NEWINGTON – 2018

SITE: WHITE TAIL RIDGE PH.3

CIVIC ADDRESS:
332 ANTLER COURT

Plans Review

GROUND FLOOR PLAN (ELEVATIONS A)

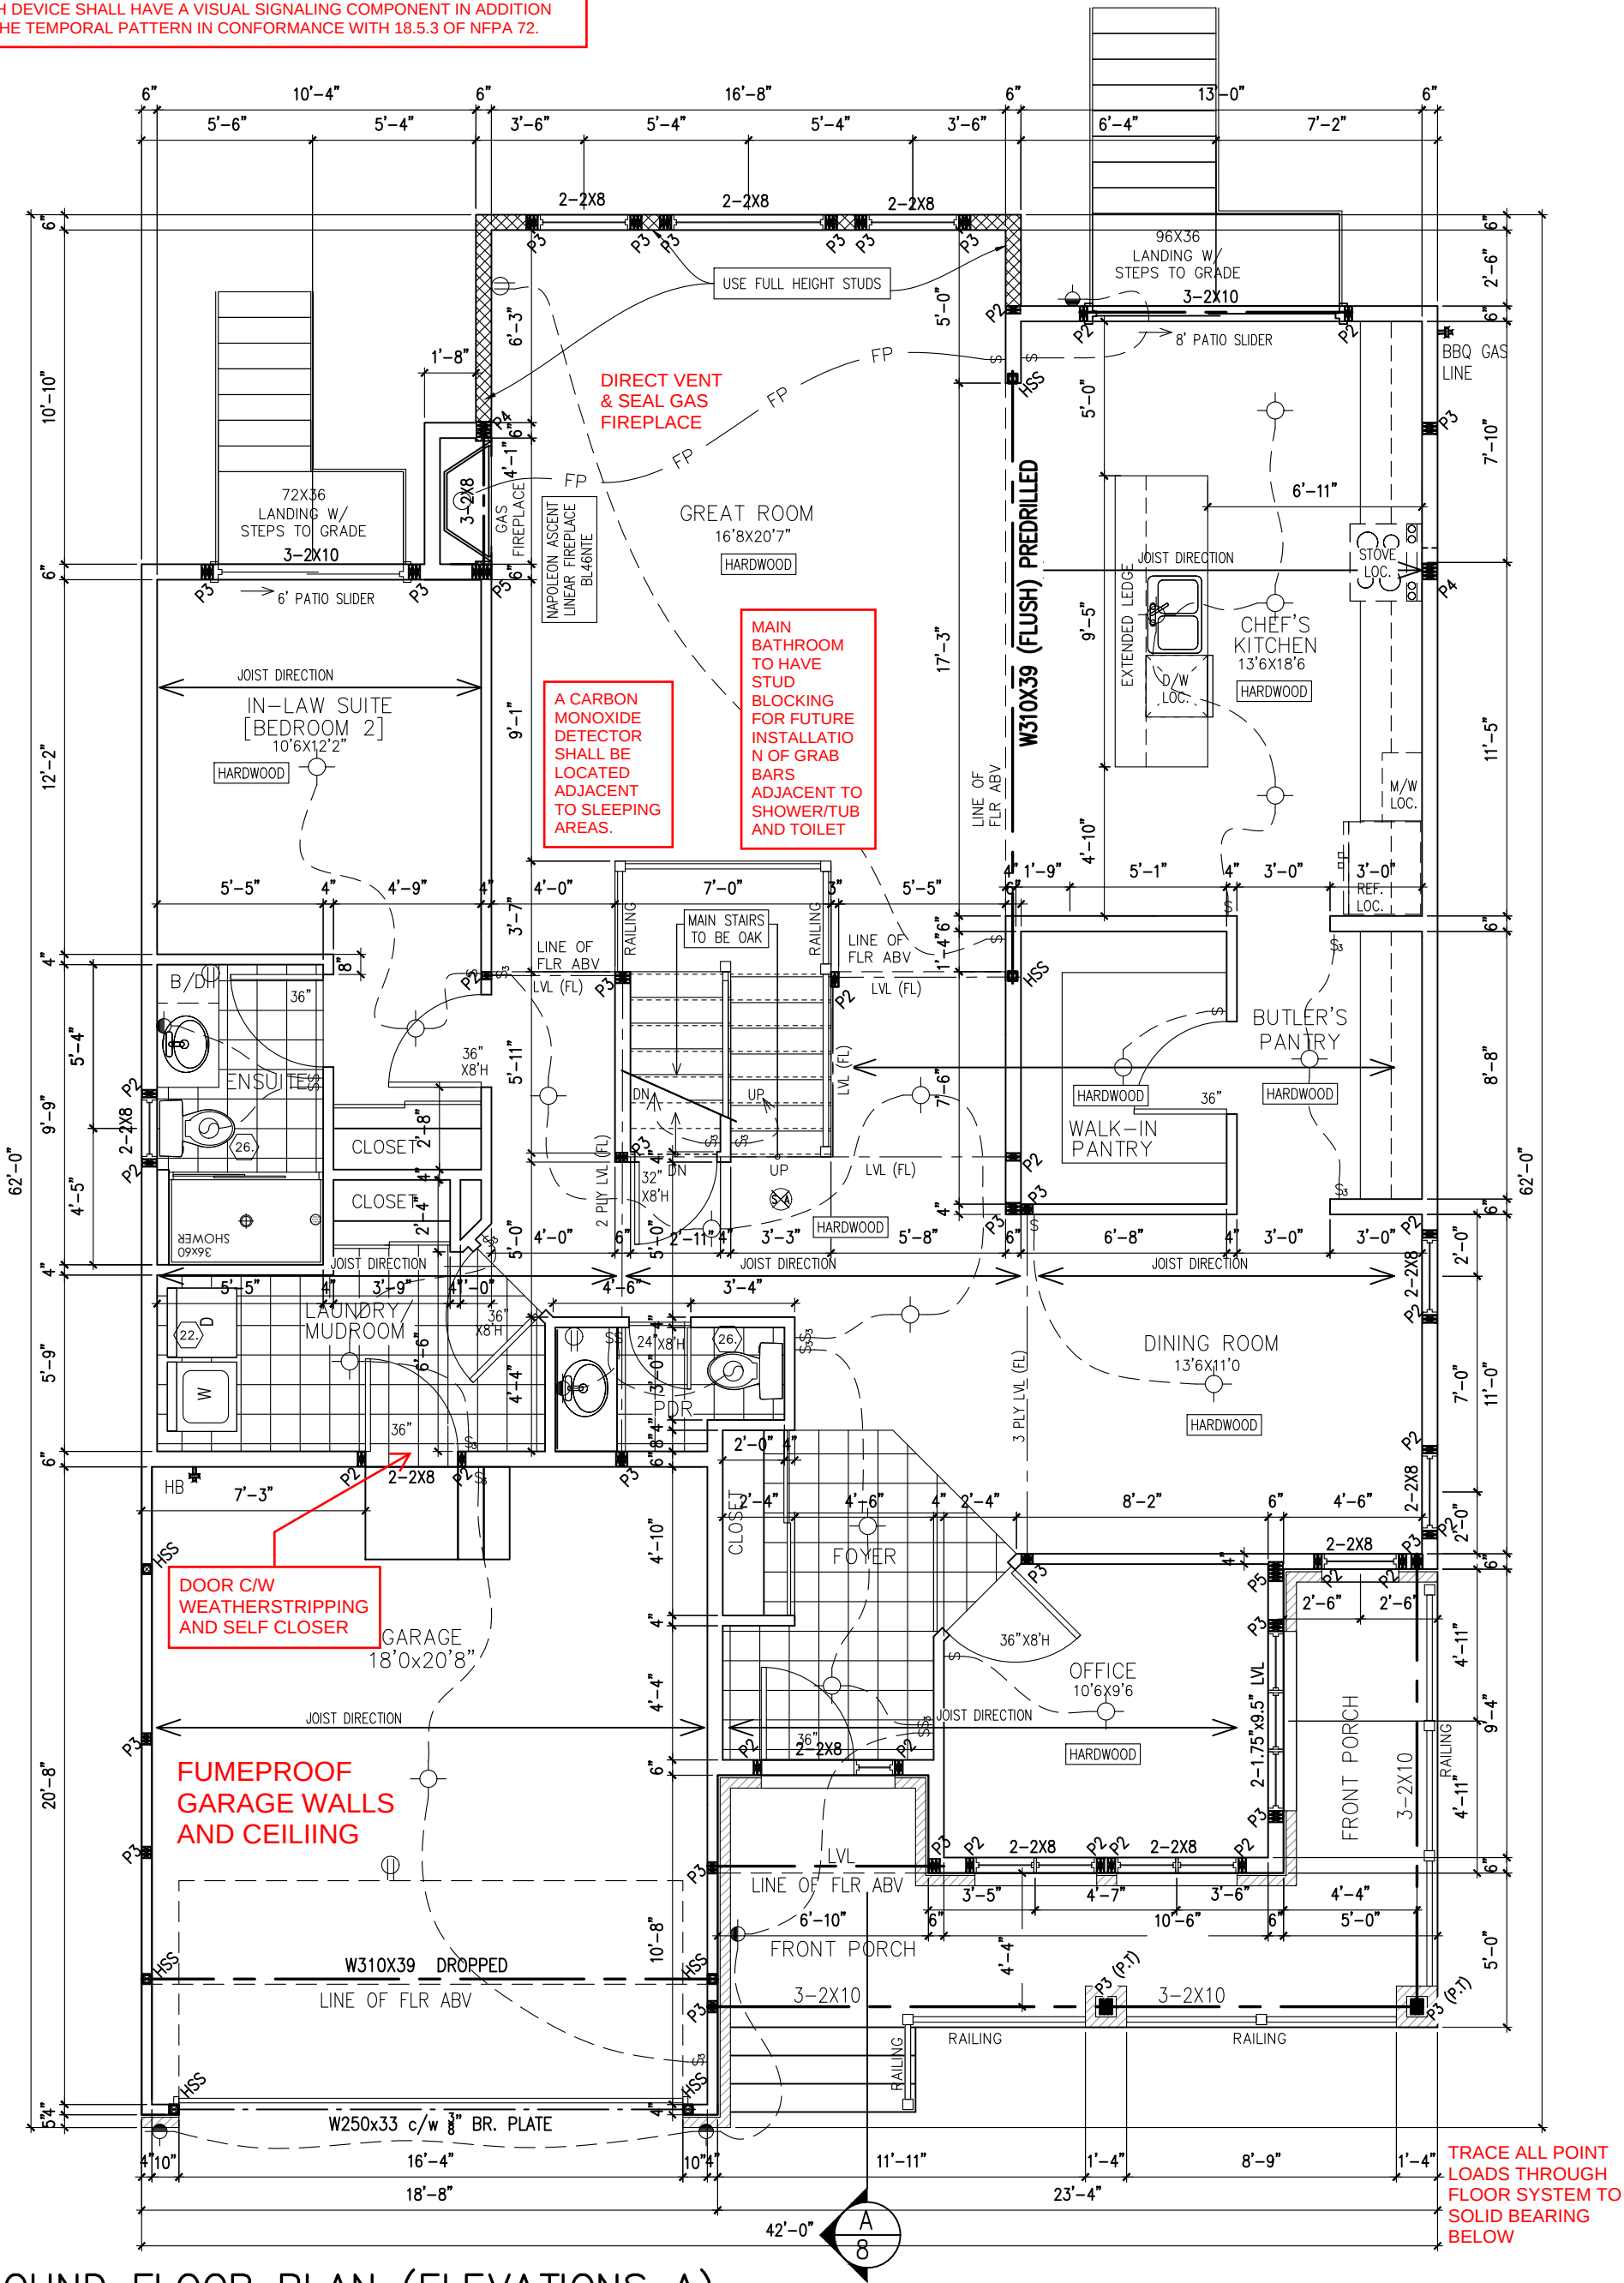
A SMOKE ALARM SHALL BE INSTALLED ON EACH FLOOR LEVEL AND WITHIN EACH SLEEPING ROOM. ALL SMOKE ALARMS SHALL BE INTERCONNECTED. EACH DEVICE SHALL HAVE A VISUAL SIGNALING COMPONENT IN ADDITION TO THE TEMPORAL PATTERN IN CONFORMANCE WITH 18.5.3 OF NFPA 72.

SECOND FLOOR PLAN (ELEVATION A)

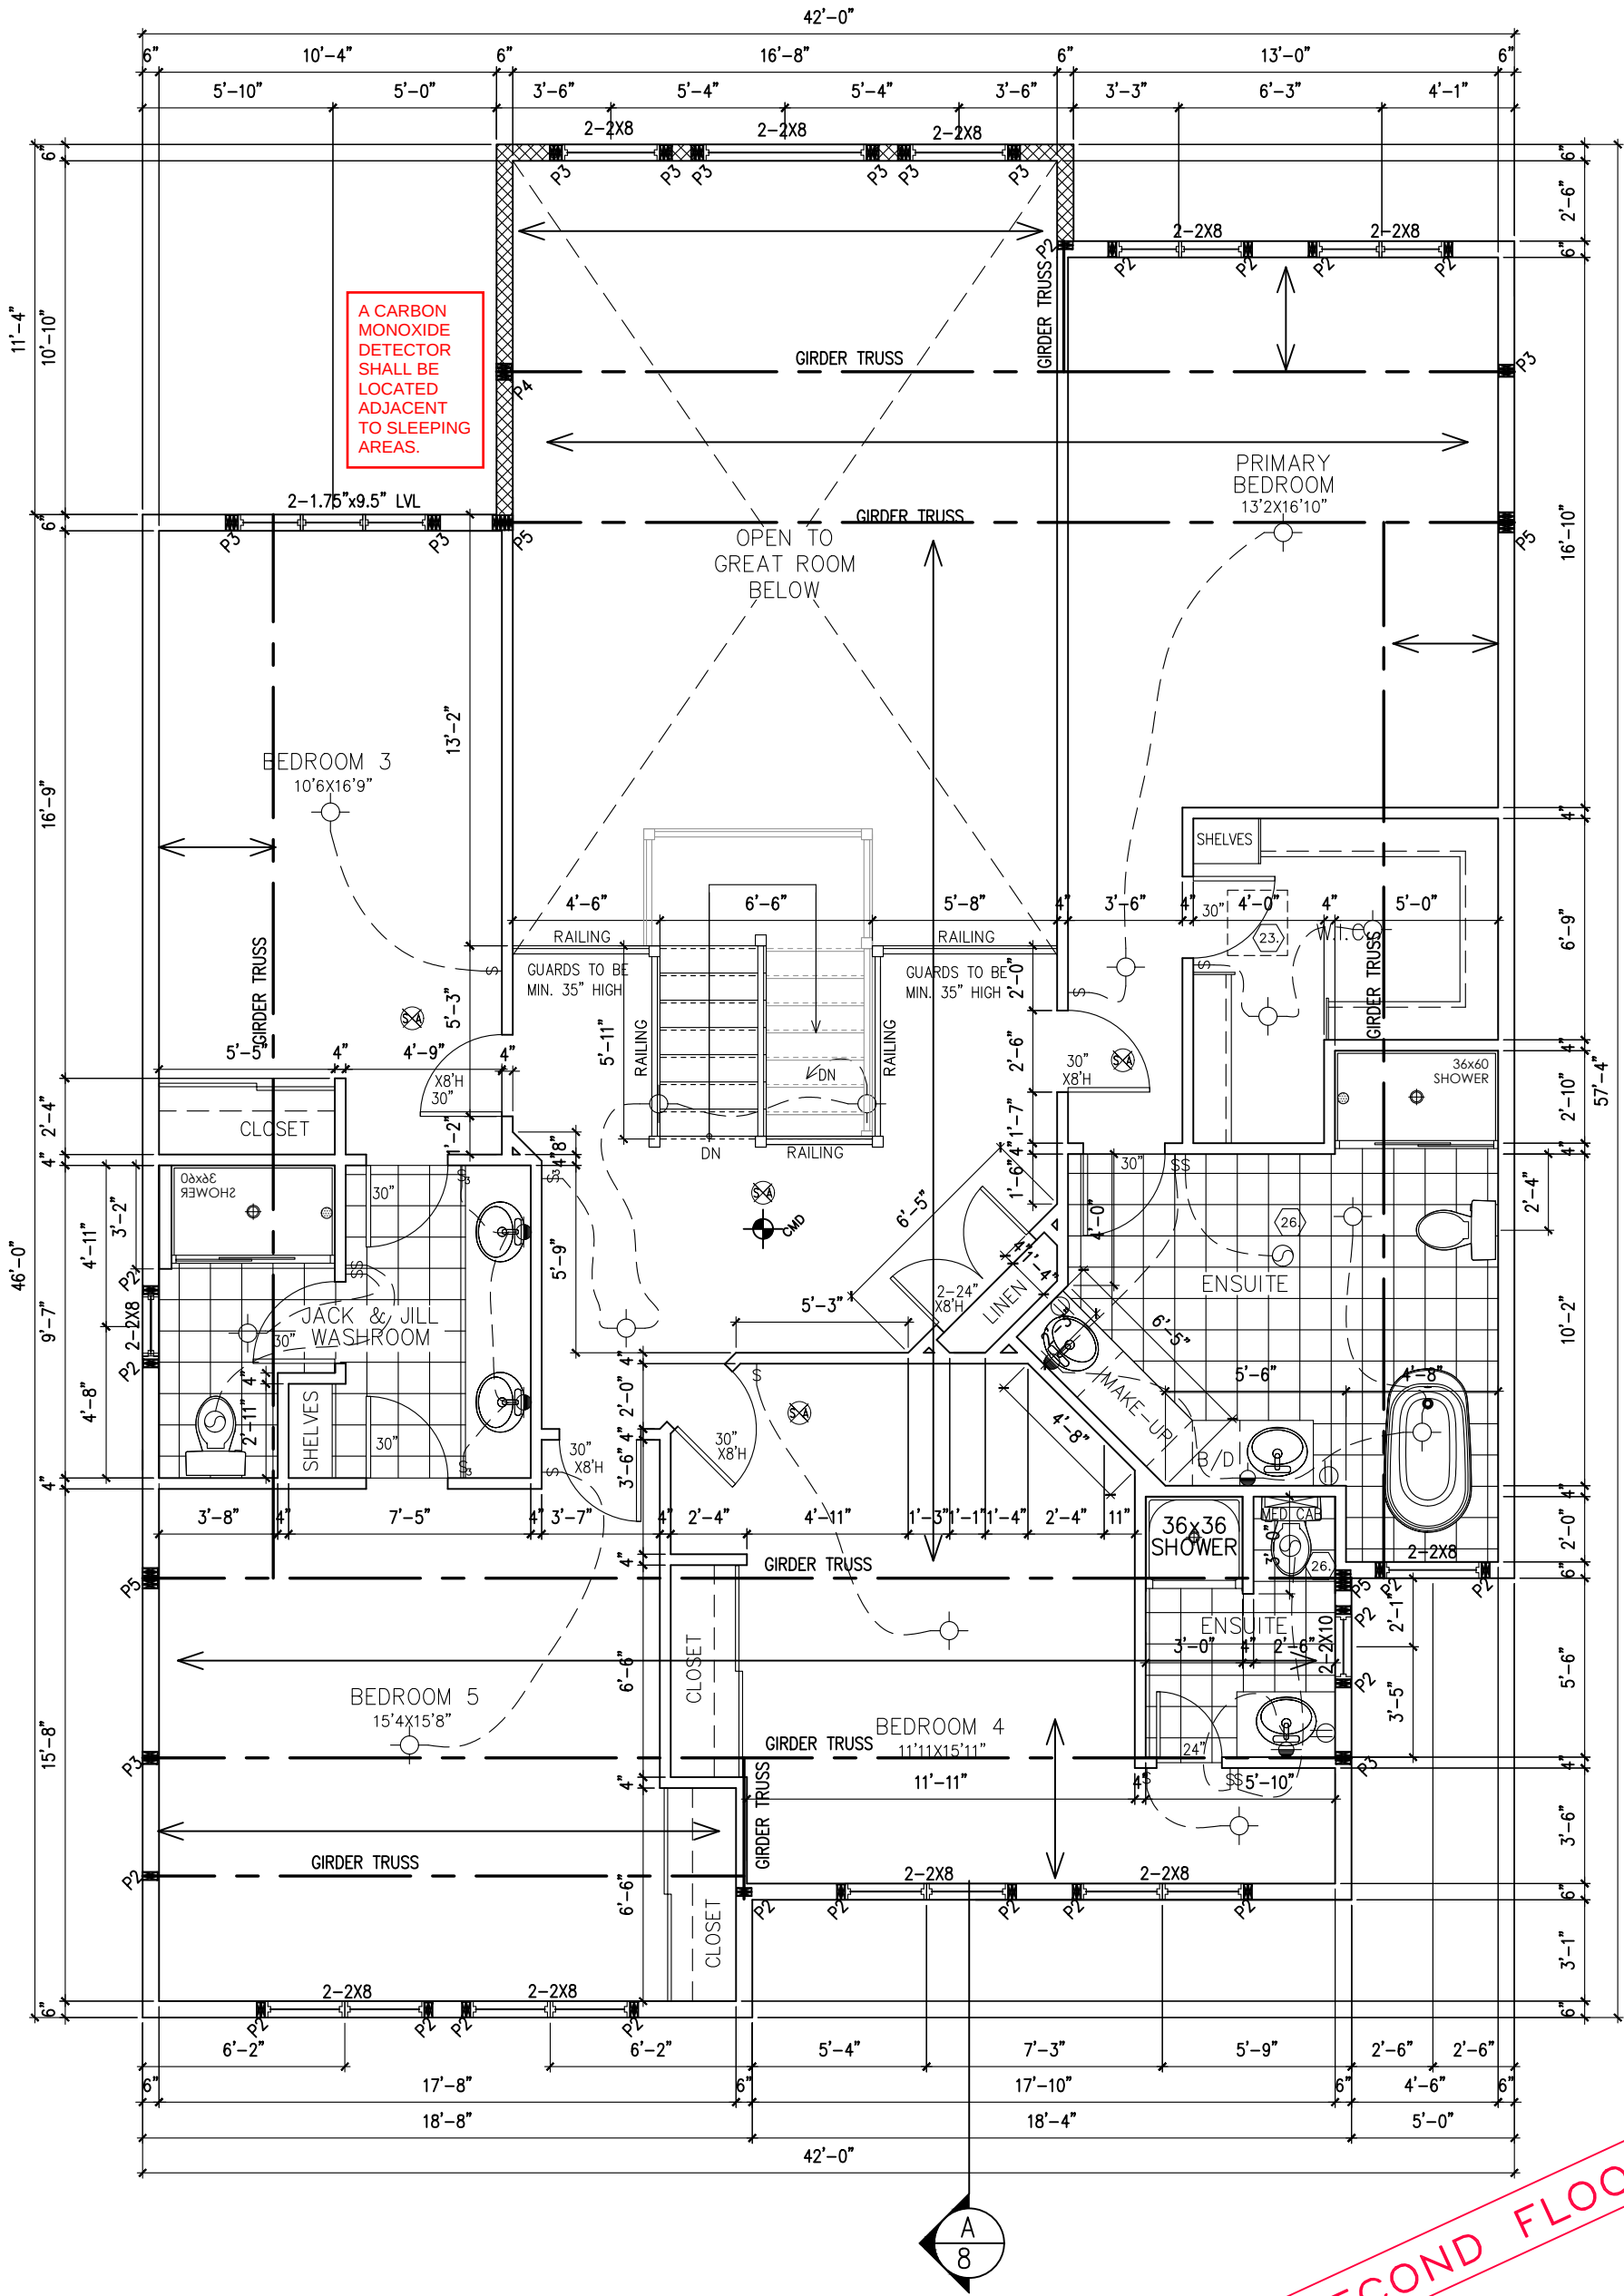
MAIN BATHROOM TO HAVE STUD BLOCKING FOR FUTURE INSTALLATION OF GRAB BARS ADJACENT TO SHOWER/TUB AND TOILET

ELEVATION A

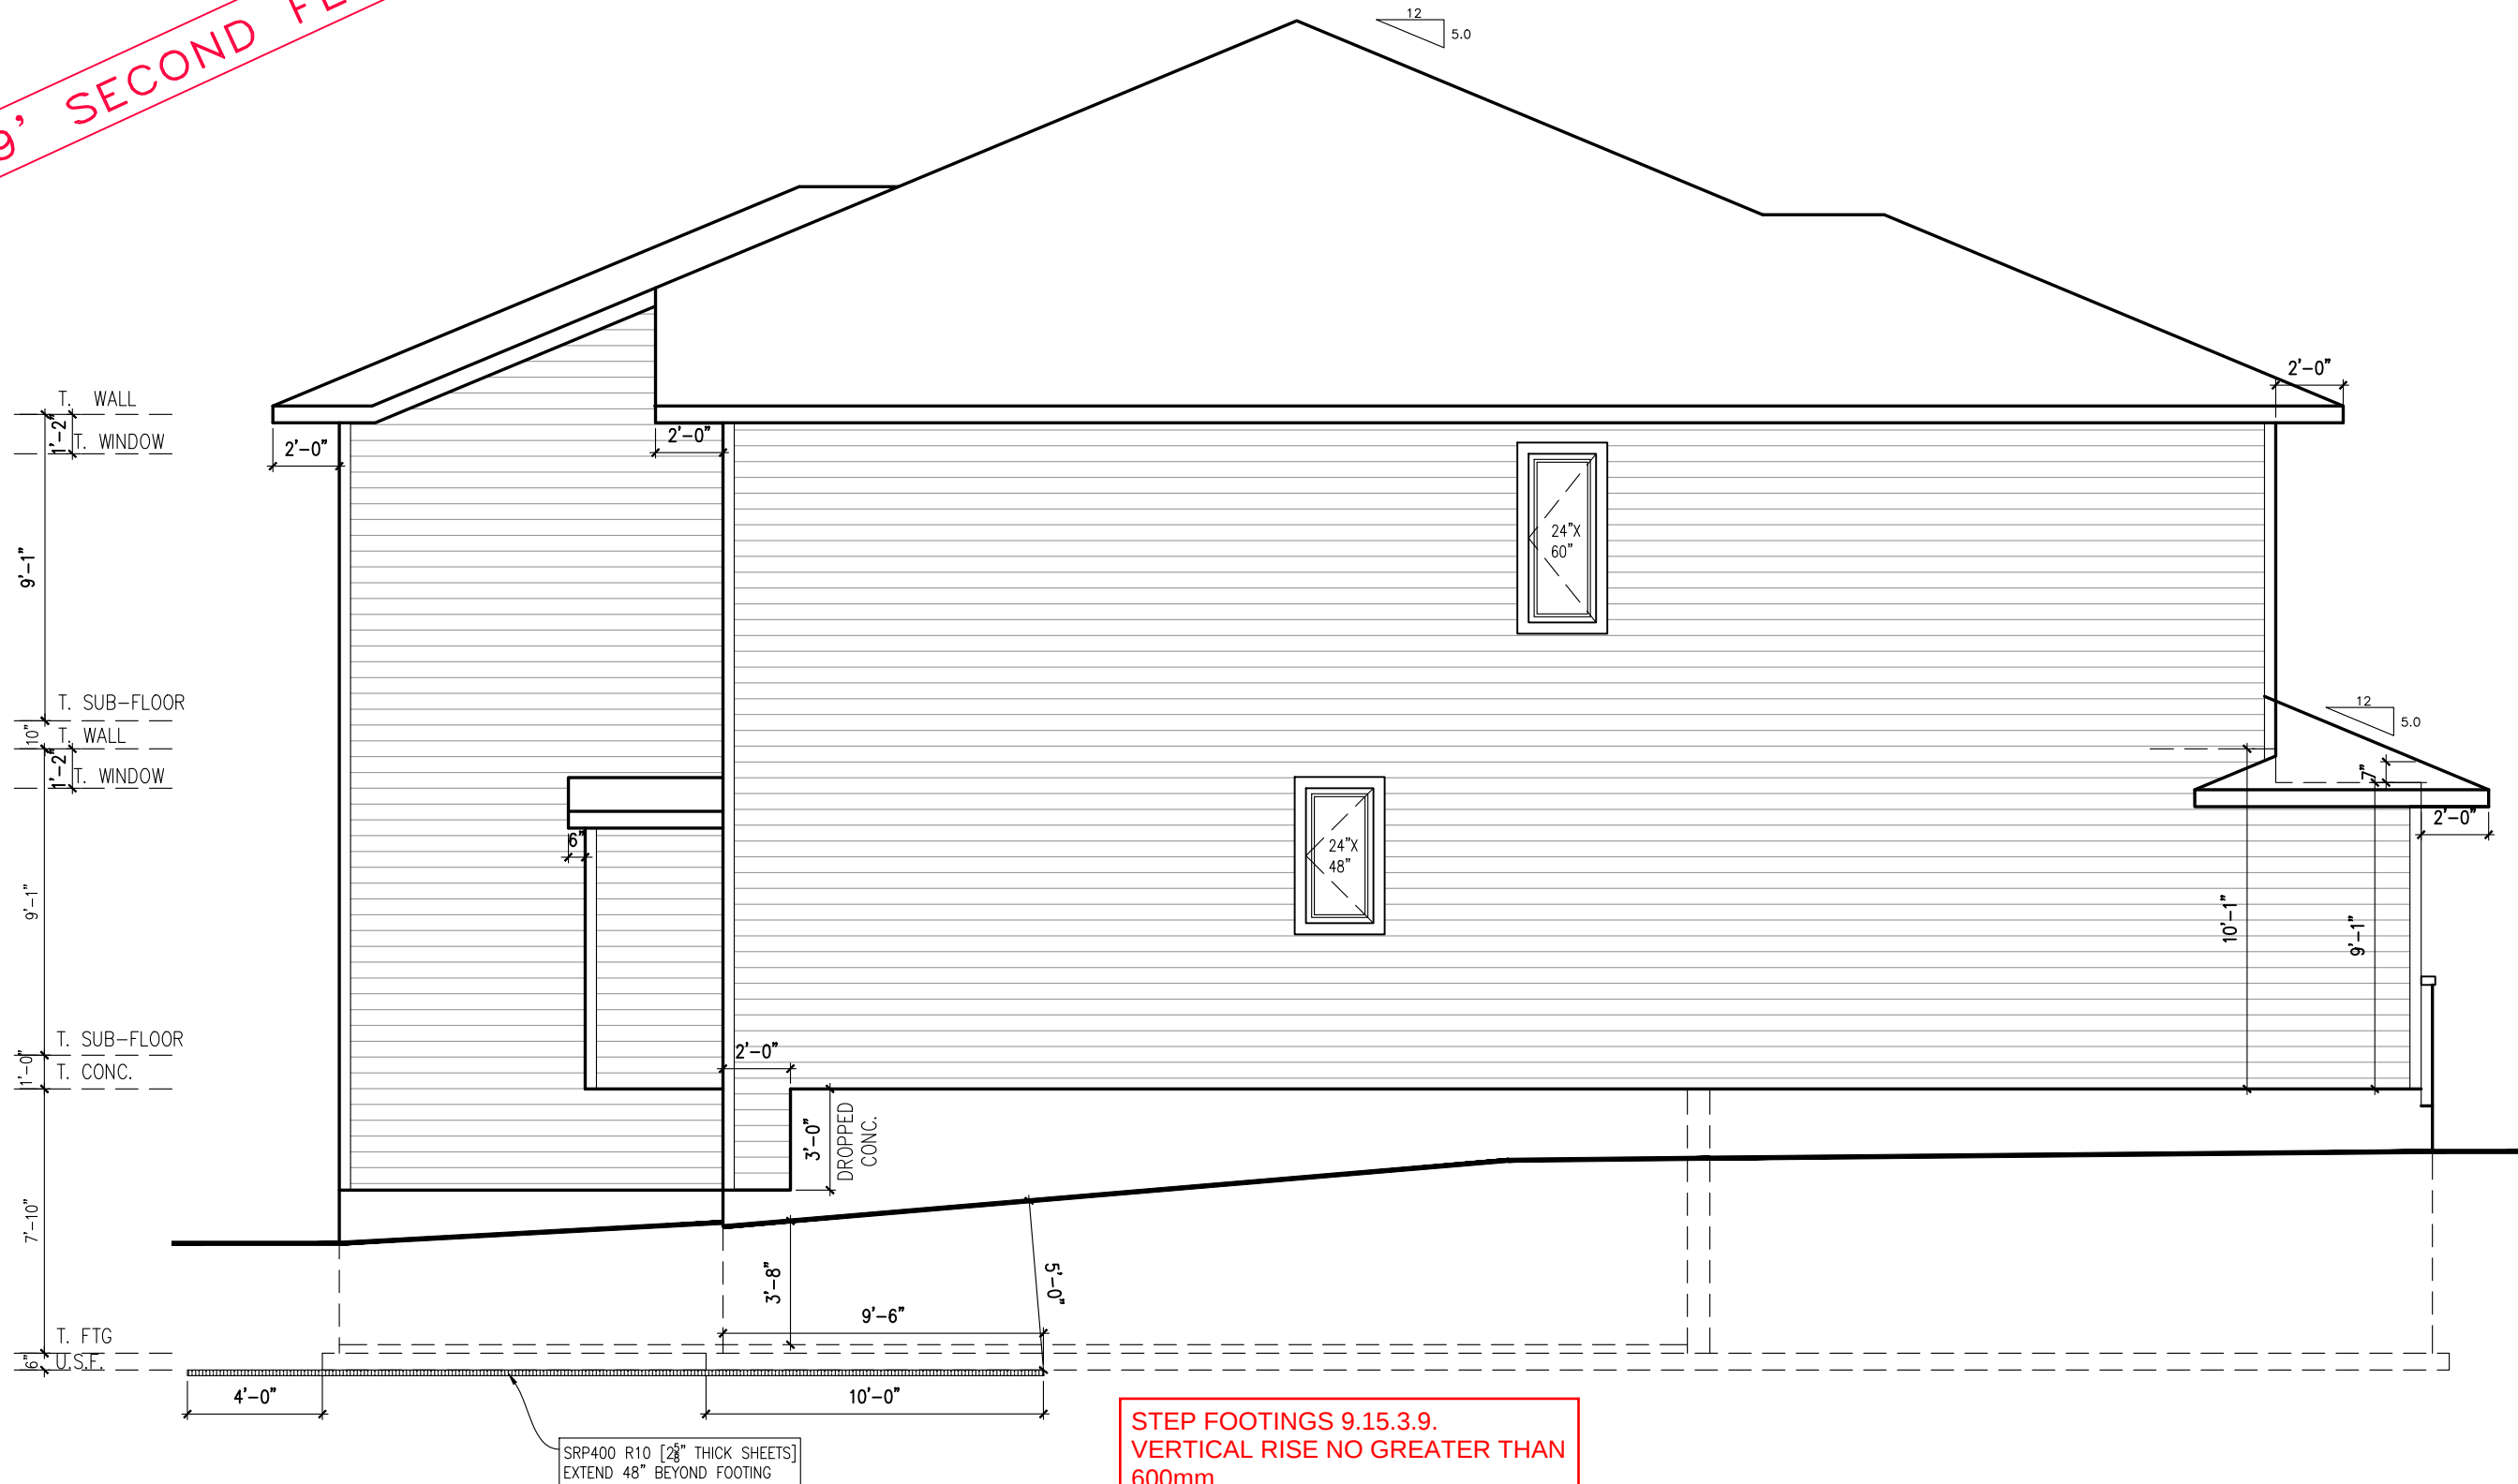
A HANDRAIL IS REQUIRED ON AT LEAST ONE SIDE OF:

- EVERY INTERIOR STAIR HAVING MORE THAN TWO RISERS
- EVERY EXTERIOR STAIR HAVING MORE THAN THREE RISERS

SRP400 R10 [2 $\frac{5}{8}$ " THICK SHEETS]
EXTEND 48" BEYOND FOOTING
